IN THE DRAWING

## **REMARKS**

### **CLAIMS SHOW CHANGES AND NUMERALS FOR DISCUSSING IN THE REMARK**

FIG.1

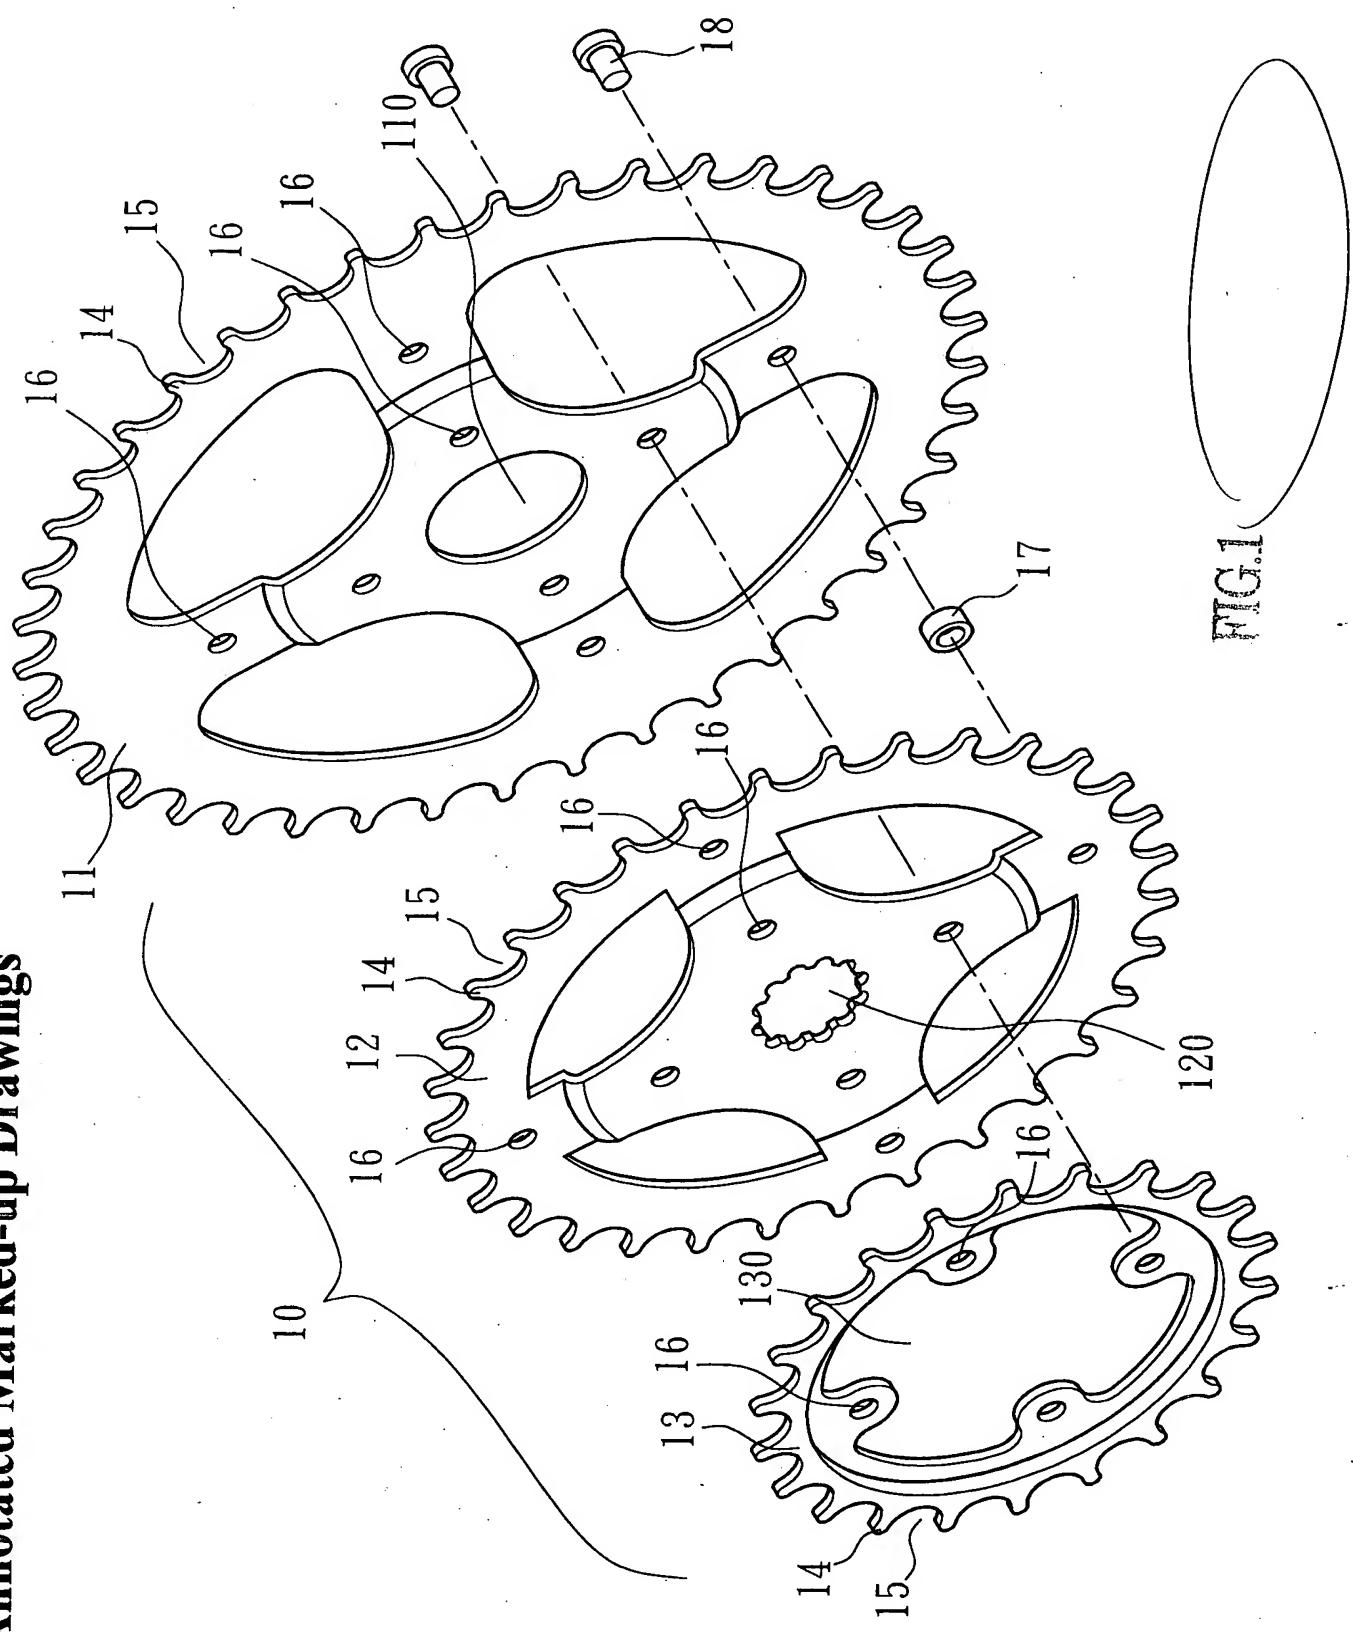
Figs. 1 to 5 are amended as the attached amended copy. In the amendment of the figure, the figures 1 to 3 are added with "Prior Art" and Figs. 4 and 5 are added with numerals 241, 241, 251, 252. No other portion is amended. Thereby, no new matter is added

FIG.4

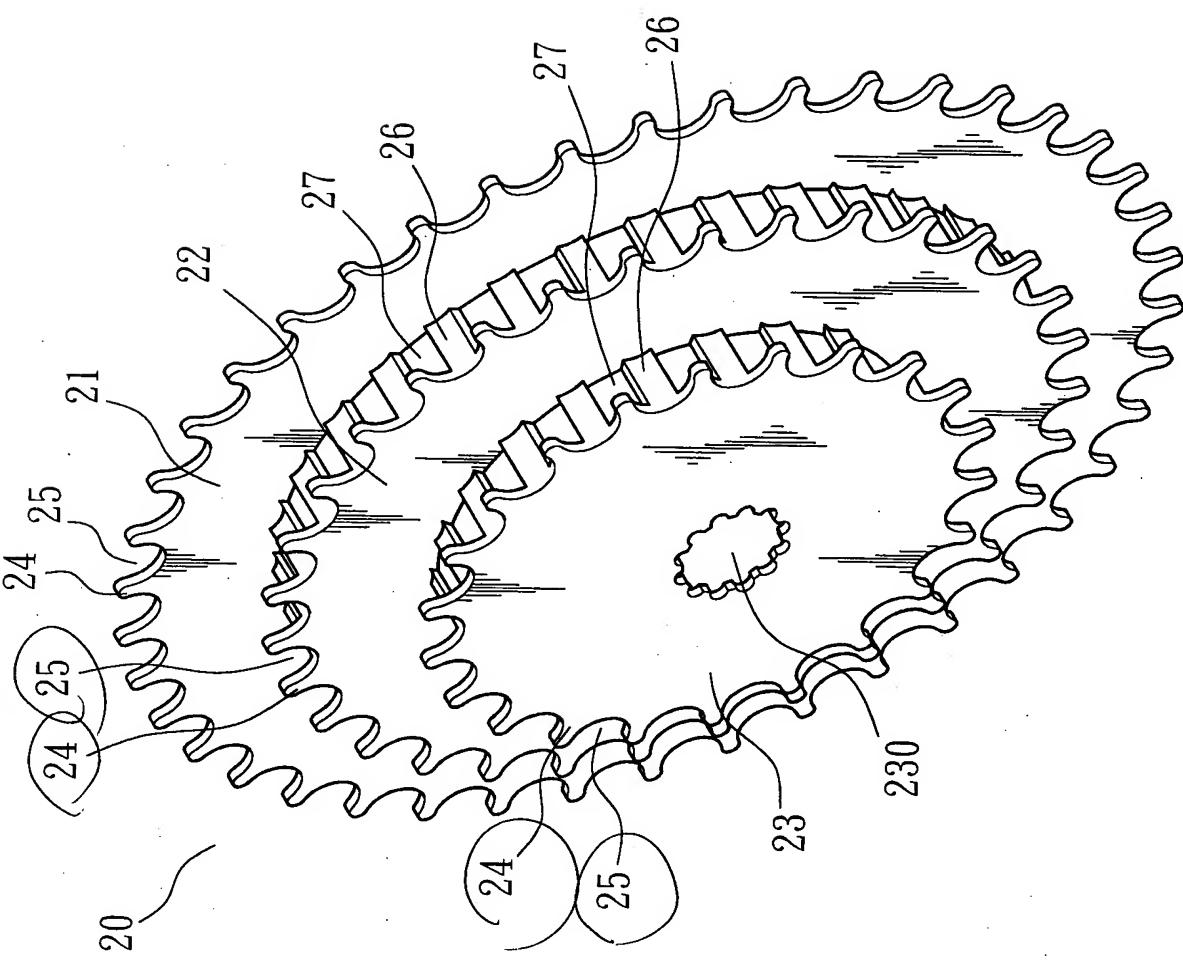
In the amendment, the teeth of the first, second and third gears are indicated 24, 241, 242 instead of the original 24. The recesses 25 for the first, second and third gears are indicated as 25, 251, 252 so that the confusions in the indications of teeth and recess are resolved.
